Memorandum

Subject: CAL FIRE Comment to NCRWQCB on Draft Order No. R1-2019-0021

Subject: Hydrologic Review of THP 1-16-056 HUM

Attachment A. A visual representation of the draft Order's proposed riparian buffers.

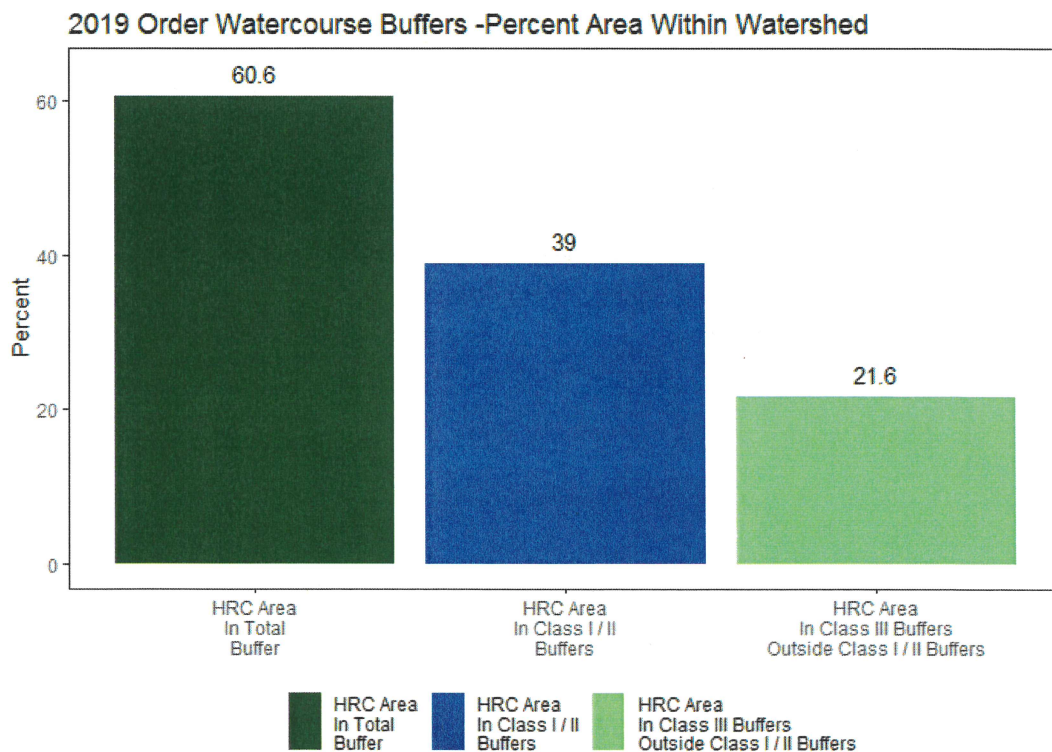
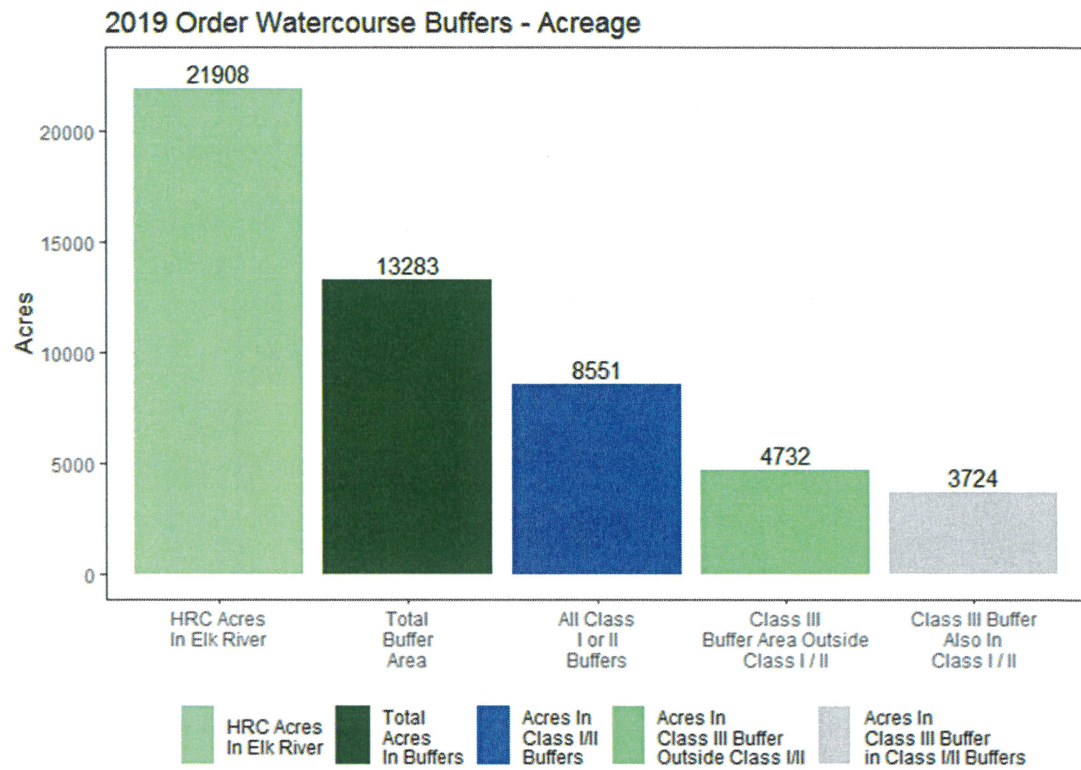
A notable omission from the draft Order and supporting documents is an evaluation of the proportion of HRC’s Elk River holdings within the proposed riparian buffers. To address

this, CAL FIRE staff performed this analysis in ArcGIS Pro using THP-mapped watercourses and HRC property boundaries. When the proposed buffers are applied to the HRC's holdings within Elk River, we see that the majority of the watershed falls within riparian buffers (Attachment A). Further analysis shows that approximately 39 percent of HRC's holding fall within Class I and/or Class II riparian buffers, and approximately 22 percent fall within Class III riparian buffers (Attachment B). Altogether, approximately 61 percent of HRC's Elk River holdings fall within the draft Order's proposed riparian buffers. The accuracy of this estimate is dependent upon the quality of the THP-mapped watercourse data used in the analysis. It is also notable that expanded riparian buffers do not stop at the hydrologic divide (i.e., ridgetops).

Given the large proportion of HRC's Elk River ownership that falls within the draft Order's proposed buffers (i.e., approximately 61 percent), these expanded riparian buffers should have a clear process-based and evidence-supported linkage to water quality. Items 43 and 44 of the draft Order state multiple rationale for why increased riparian buffer expansion relate to hillslope water quality indicators and will achieve hillslope targets listed in TMDL Table 2. However, the effectiveness of the specific widths of the proposed riparian buffers in the draft Order are not supported by the published or gray literature, or evidence provided in the draft Order. Even if evidence supported the effectiveness of the increased buffers, the expanded riparian buffers generally apply to mitigating a relatively small proportion of the anthropogenic sediment load (i.e., primarily low order channel incision and lateral bank erosion) identified in the Tetra Tech Report (2015) and the "Peer Review Draft: Staff Report to Support the Technical Sediment Total Maximum Daily Load for the Upper Elk River" (NCRWQCB, 2013). These points have been raised in detail when expanded buffers were recommended for a 2016 HRC Elk River watershed THP (Coe, 2016; see Attachment C).

Figure 2. The route taken by the Review Team in Unit 2.

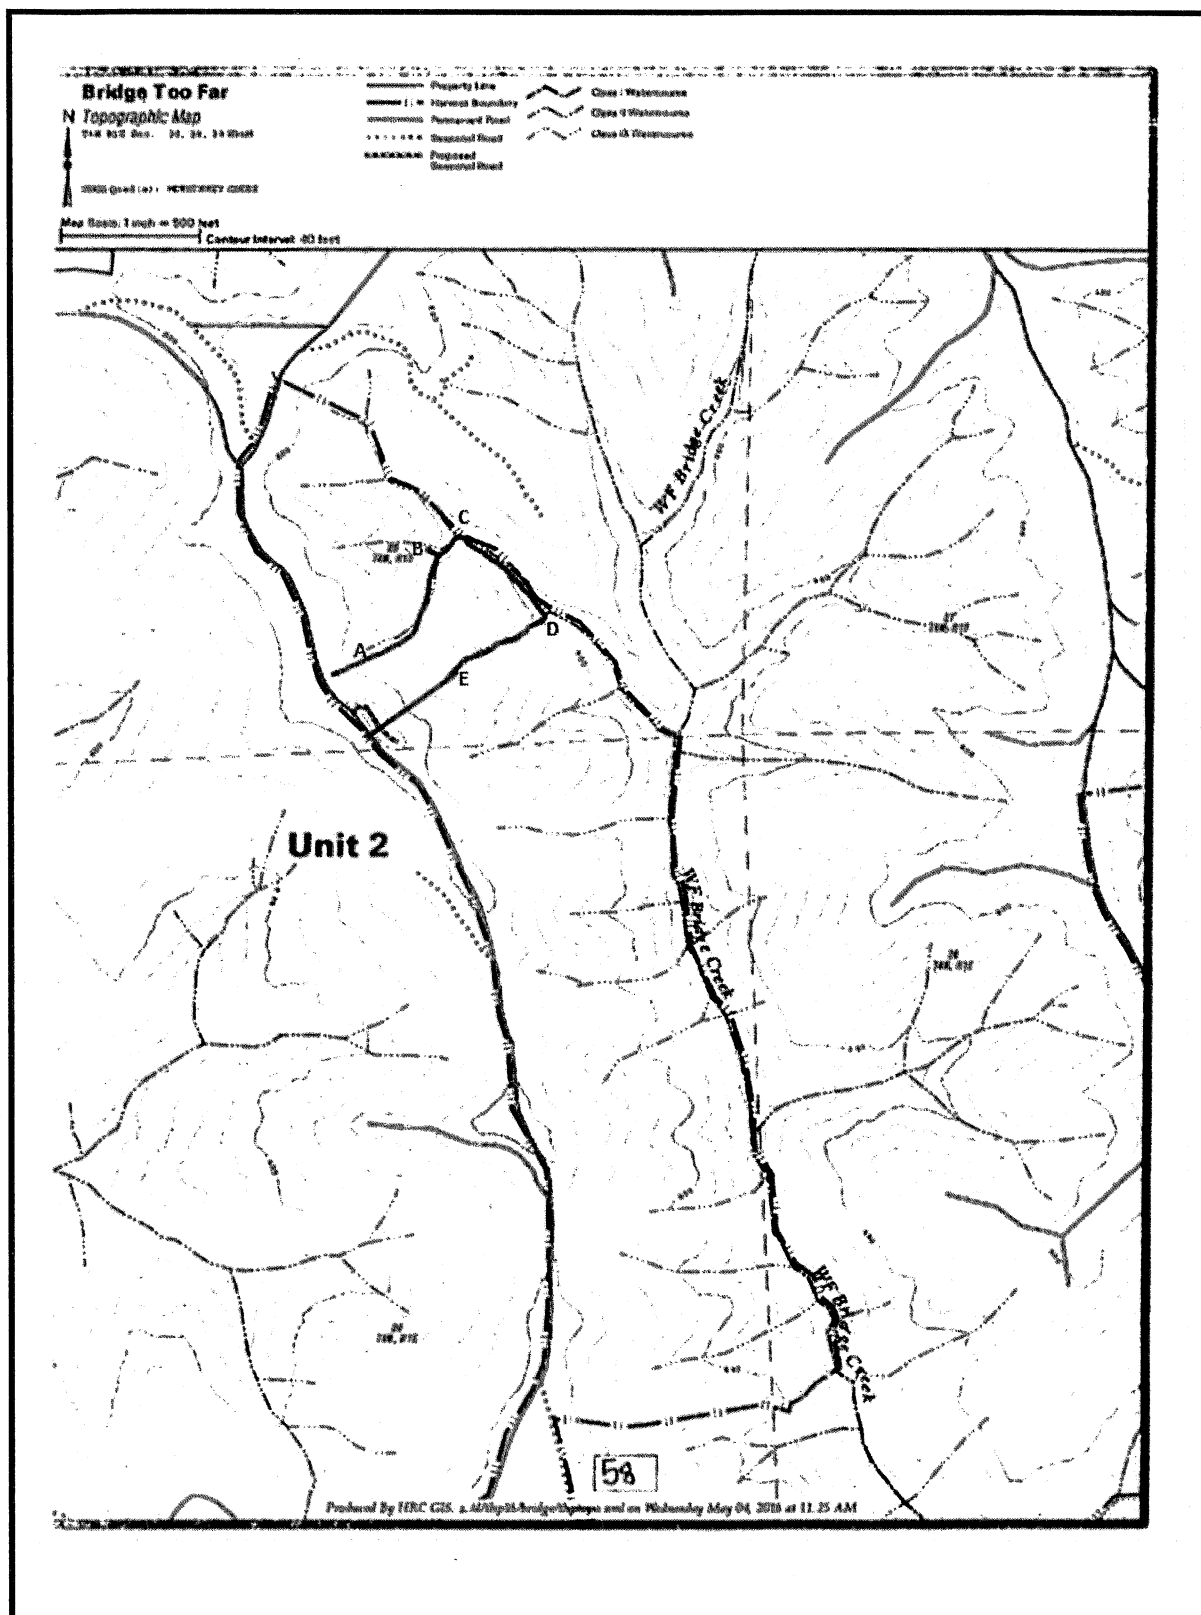
1-16-056 HUM - Unit 2: Unit 2 is a large selection harvest unit which is proposed to be cable logged. The field PHI Team (Team) walked down to the channel head of the first order (Strahler, 1957) Class III watercourse shown in Figure 2 (see point A). The location of the channel head appeared to be properly identified as no channelized flow was observed above where the channel head was flagged. The area where the channel head was located can be characterized as hydraulically rough due to the prevalence of live vegetation, thick layers of duff, and a relative abundance of large woody debris (Figure 4). Below the channel head, the watercourse was discontinuous, relatively entrenched, with generally subvertical and well vegetated banks. The channel exhibited a relatively steep and stepped profile with generally subvertical discontinuities (i.e., headcuts) present. Channelization was discontinuous, with subsurface channelization/piping occurring in conjunction with large woody debris (Figure 5) and thicker accumulations of colluvium and/or anthropogenically-induced valley infilling from first cycle logging.

The Team continued down to the confluence of two Class III watercourses (Figure 2; Point B), where the watercourse became a second order channel. Below the confluence the watercourse displayed slightly more consistent signs of channelization. However, valley gradient, the condition of the banks, and the roughness of the channel did not change significantly. The second order Class III watercourse combined with another second order Class III watercourse to form a third order Class III watercourse (Figure 2; Point C). This larger third order Class III watercourse was characterized by a much gentler valley gradient, a broader valley bottom (Figure 6), but largely remained a discontinuous channel. Watercourse banks were well vegetated and did not show signs of active erosion, although there was evidence of subsurface flow and/or erosion voids along the axis of the channel, particularly in areas with larger accumulations of large woody debris (Figure 7).

The third order Class III watercourse transitioned into a Class II watercourse shortly above point D on Figure 2. This transition appeared to be accurately identified by the RPF. At point D, the Team walked up a first order Class III watercourse. This watercourse displayed similar characteristics and conditions to that of the first watercourse walked between points A and B (Figure 2). The Team continued to walk the watercourse until the channel head was reached (Point E, Figure 2). The channel head at point E was very similar to the one discussed for point A (Figure 2).
